**FLOODWAY DEVELOPMENT PERMIT #851-24-000641-PLNG:
COULTER**

**FLOODWAY FLOODPLAIN DEVELOPMENT PERMIT REQUEST
851-24-000641-PLNG:
COULTER**

ADMINISTRATIVE DECISION & STAFF REPORT

GRADING PLAN

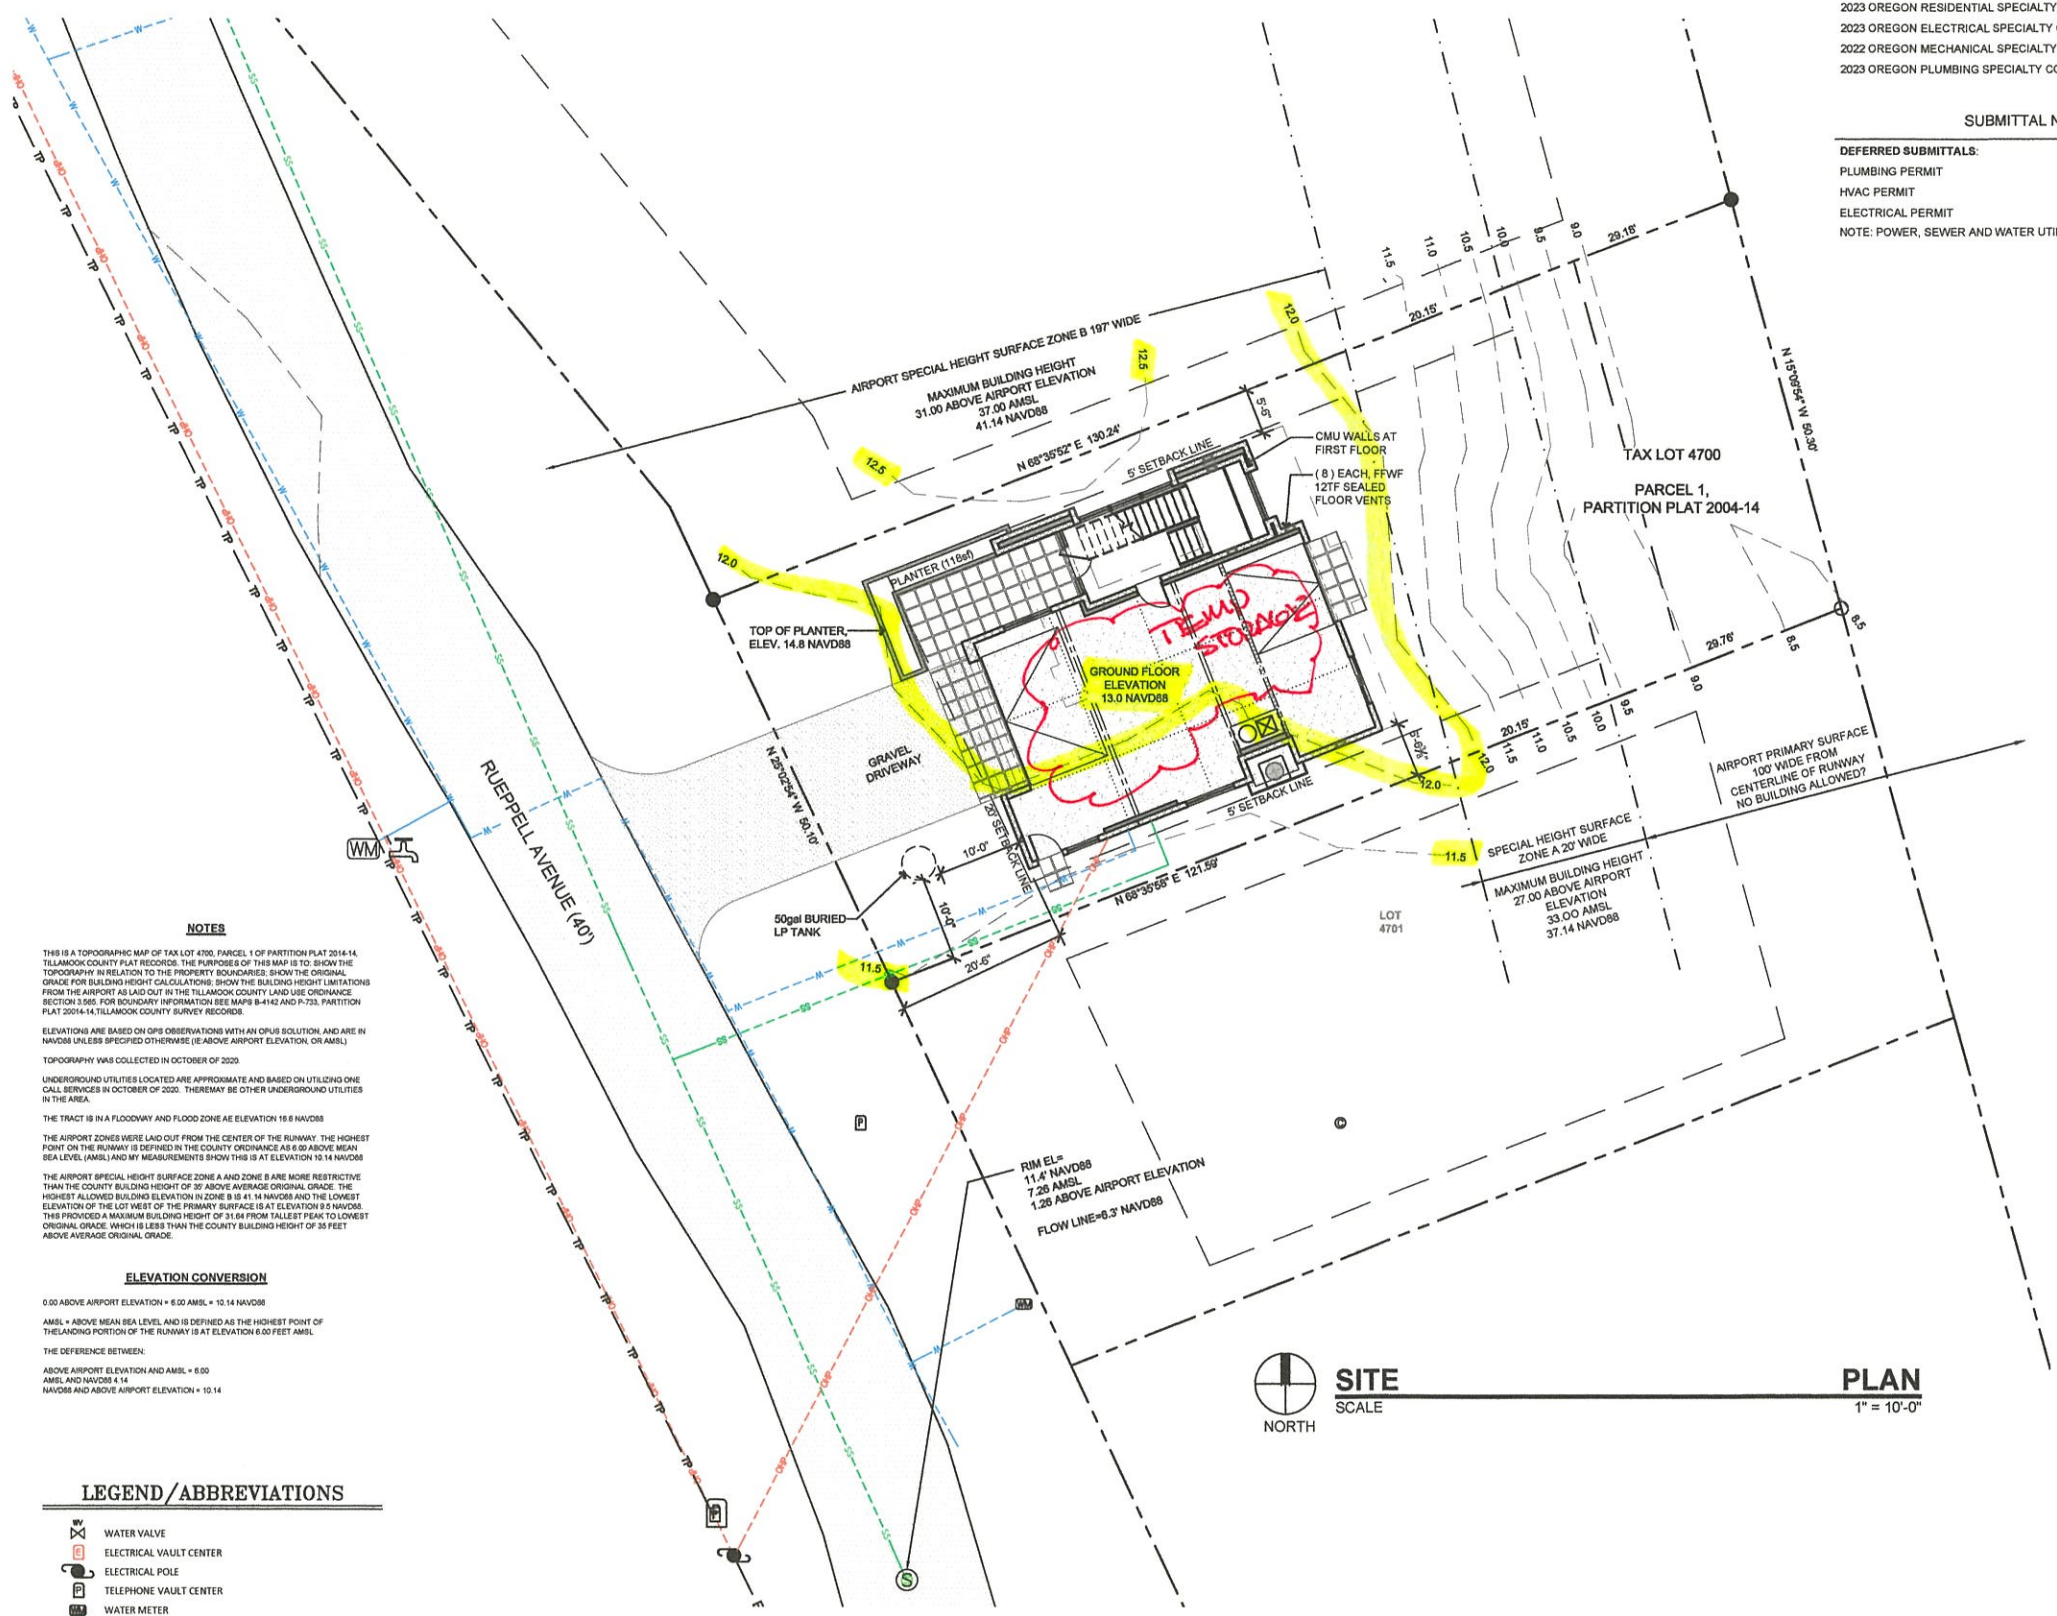
- Completed Floodplain Development permit, including:
 - Provide fill volumes in both added and removed, rather than just indicating net 0.
 - Site plan, neither no-rise analysis, concludes any values of fill volume. Unsure what is or isn't being added/removed.

- Grading Plan, as applicable for any fill/removal and/or grading performed on site for development.
 - Illustrate existing and proposed site elevations in plan and profile views, as necessary to describe activities.

- See attached Grading Plan dated 04.12.2025, also see re-submitted drawings dated April 4th 2025 for illustrated elevations.
 - Pre and post grade must be identified.

- Indicated on sheet A0.1
 - Specify location and quantity of fill and excavation, source of fill materials & onsite disposal location(s).
 - See attached grading plan dated 04.12.2025

- See attached Grading Plan dated 04.12.2025.
 - Dimensions or square footage of proposed dwelling should be contained in 'Dwelling' category.
 - This information is on sheet A-1.1

- No significant trees or vegetation on this property, just grass in the developed footprint and some scotch broom in non-disturbed areas. See grading plan dated 04.12.2025 for fill and excavation activities.
